Clarify EEE Quiet Signaling

Contribution to IEEE 802.3cy

Marvell

May 3, 2022

Figure 149–13—Timing periods for LPI signals when Slow Wake not active

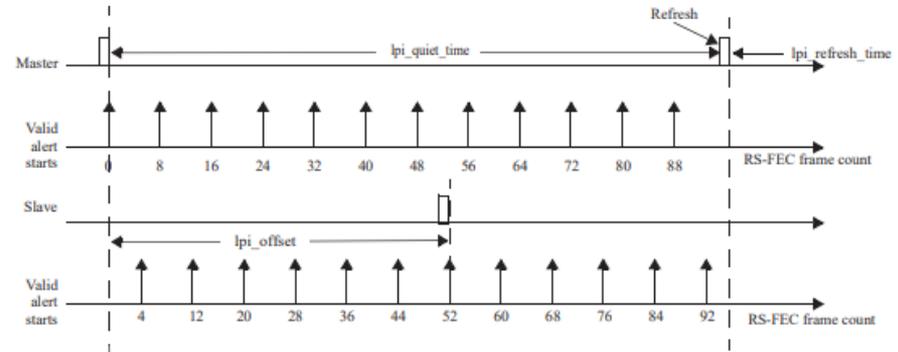
The 149.3.6.2 text has two problems:

- It is ambiguous about what shall be transmitted on MDI, because 802.3ch does not define mapping to “zero voltage”, so PCS outputting zeros does not necessarily imply “zero voltage” on the MDI
- It does not state anything about transition period from “normal transmission” to quiet period

- When transitioning to lower internal power state, the transmitter may introduce minor “glitches” on the line
- When transitioning to lower internal power state, the receiver may have some “glitches” in its internal signals
- Allowing for clearly specified transition period can benefit both transmitter and receiver, and help interoperability

In 802.3cy, the text from 149.3.6.2 should be changed to

When entering quiet mode, the receiver shall ignore the first 330 ns (one RS-frame). During this time, the transmitter may output any signal within the bounds of PMA electrical limitations described 165.5.3. After this transition, the PCS transmitter shall pass all zeros to the PMA and the PMA shall transmit silence on the MDI.
